PREVOST

SAFETY RECALL

SR23-304

DATE :	June 2023	SECTION :	18 BODY
SUBJECT:	Missing Weld on Passenger Flip-Up Seat

FLIP-UP SEAT FRAME

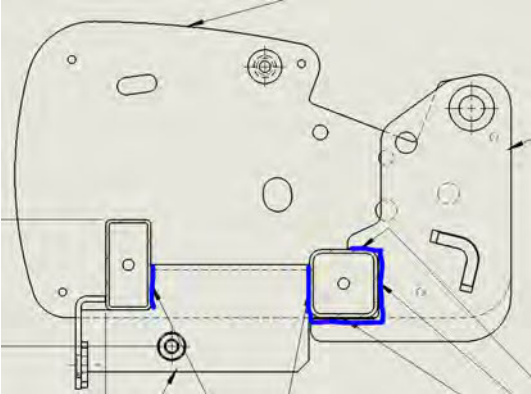
- 1. The tubes, brackets, and center pivot are to be welded as shown below in blue. The weld will be on both sides of the recline bracket and center pivot.

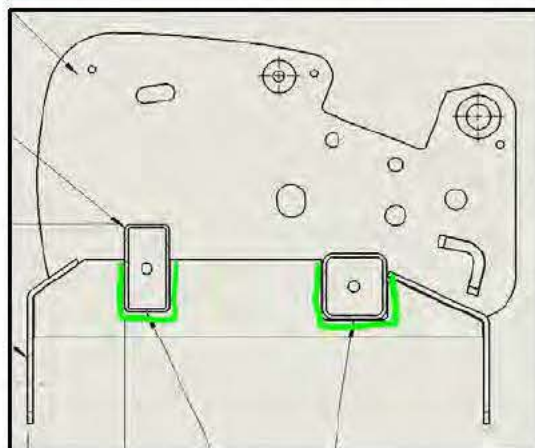
2. The tubes and brackets are to be welded as shown below in green. The weld will be on both sides of the pedestal brackets.
